**TSG RAN Meeting #22**  
**Maui, USA, 9 - 12 December 2003**

**RP-030678**

**Title** CR (Rel-5 only) to TS 25.427 on Signalling support for soft handover indicator  
**Source** TSG RAN WG3  
**Agenda Item** 7.4.3

⌘ **25.427 CR 090** ⌘ rev **1** ⌘ Current version: **5.2.0** ⌘

Figure 22: Structure of the payload for the RADIO INTERFACE PARAMETER UPDATE control frame

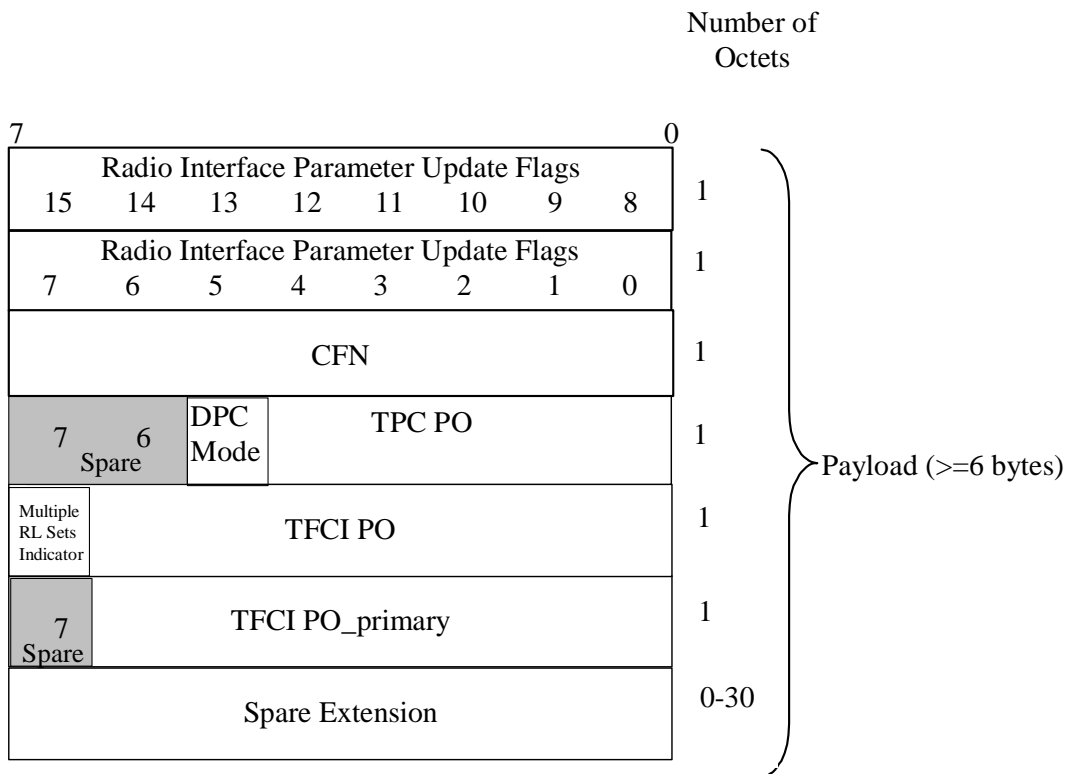
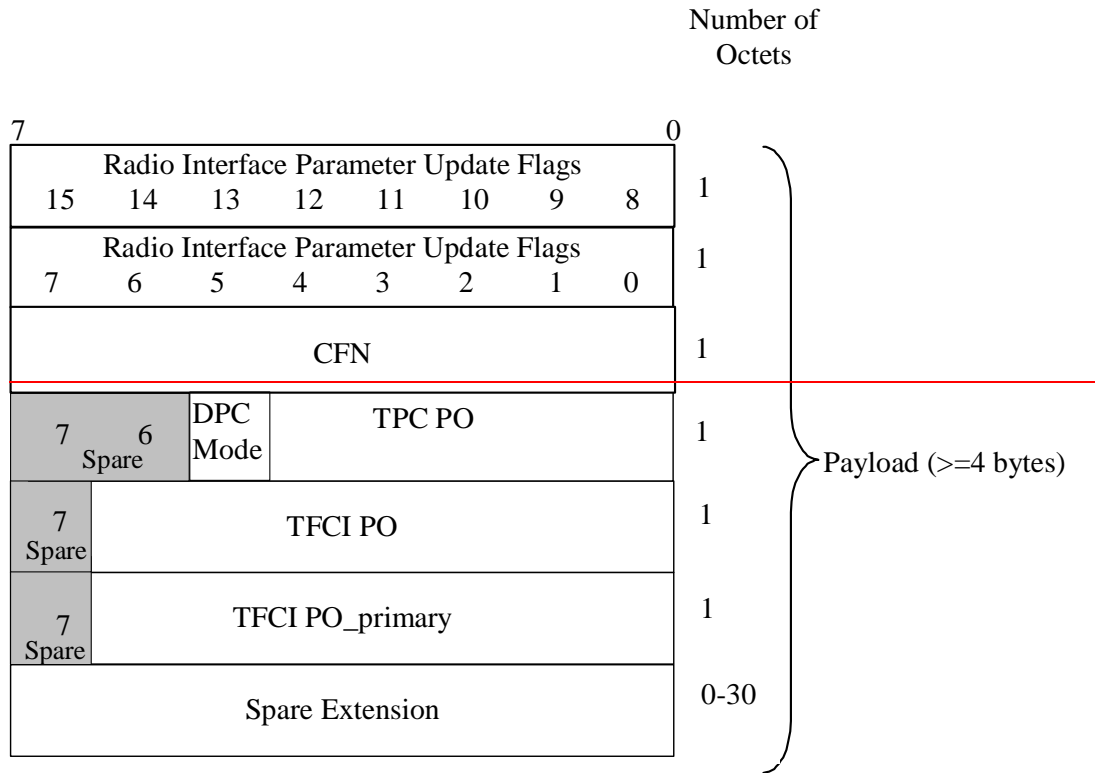
The figure 22 shows the structure of the payload when the control frame is used for signalling radio interface parameter updates.

Bit 5: Indicates if the 5<sup>th</sup> byte (bit 7) of the control frame payload contains a valid Multiple RL Sets Indicator (1) or not (0);

Bit ~~5~~6-15: Set to (0): reserved in this user plane revision. Any indicated flags shall be ignored by the receiver.

#### 6.3.3.9.8 Multiple RL Sets Indicator

**Description:** Multiple RL Sets Indicator indicates whether the UE has several RL Sets or not.

**Value range:** {0=UE has only one RL Set, 1=UE has several RL Sets}.

**Field length:** 1 bit.
